Access Compliance Report

Public Rights-of-Way

Intersection ID: 6911	Main Street: CINDY_LN	Cross Street: CINDY_PARK_DR	Location: NE
ADA ID: 2AE957C754EC	Ramp Type: Perp	Initial Pass/Fail: Fail	Overall Compliance: No
Severity Score: 8.75			
Codes/Mitigation Info/Possible Solution		Field Measurements/Component Compliance

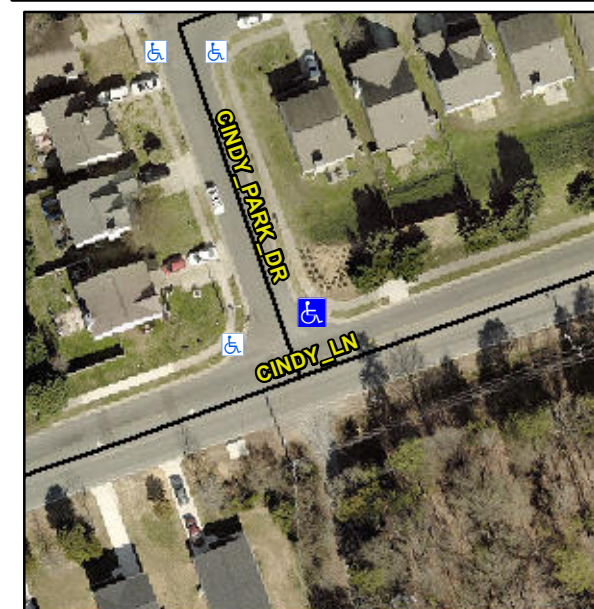
Not Found, R304.5.1

Compliance	Description	Data	Compliance	Description	Data
N/A	Ramp Length (in)	46.0	Yes	Ramp Slope (%)	7.0
No	Ramp Width (in)	41.0	Yes	Ramp XSlope (%)	1.9
N/A	Flare Type LT	N/A	N/A	Flare Type RT	N/A
N/A	Flare Slope LT (%)	N/A	N/A	Flare Slope RT (%)	N/A
N/A	Flare Traversable LT?	N/A	N/A	Flare Traversable RT?	N/A
N/A	Landing Length (in)	N/A	N/A	DWS Provided?	N/A
N/A	Landing Width (in)	N/A	N/A	DWS Contrast?	N/A
N/A	Landing Slope (%)	N/A	N/A	DWS Length (in)	N/A
N/A	Landing X Slope (%)	N/A	N/A	DWS Full Width?	N/A
N/A	Landing Curb? (Y/N)	N/A	N/A	DWS Offset (in)	N/A
N/A	Shared Landing?	N/A			
N/A	Gutter Ponding?	N/A	N/A	Gutter Slope (%)	N/A
N/A	Gutter Lip Ht (in)	N/A	N/A	Gutter X Slope (%)	N/A
N/A	Painted X Walk1?	No	N/A	Painted X Walk2?	N/A
	X Walk 1 Direction	To W		X Walk 2 Direction	N/A
N/A	X Walk 1 Width (in)	N/A	N/A	X Walk 2 Width (in)	N/A
	X Walk 1 Slope (%)	1.4		X Walk 2 Slope (%)	N/A
	X Walk 1 X Slope (%)	0.1		X Walk 2 X Slope (%)	N/A

Remove & Replace Entire Ramp.
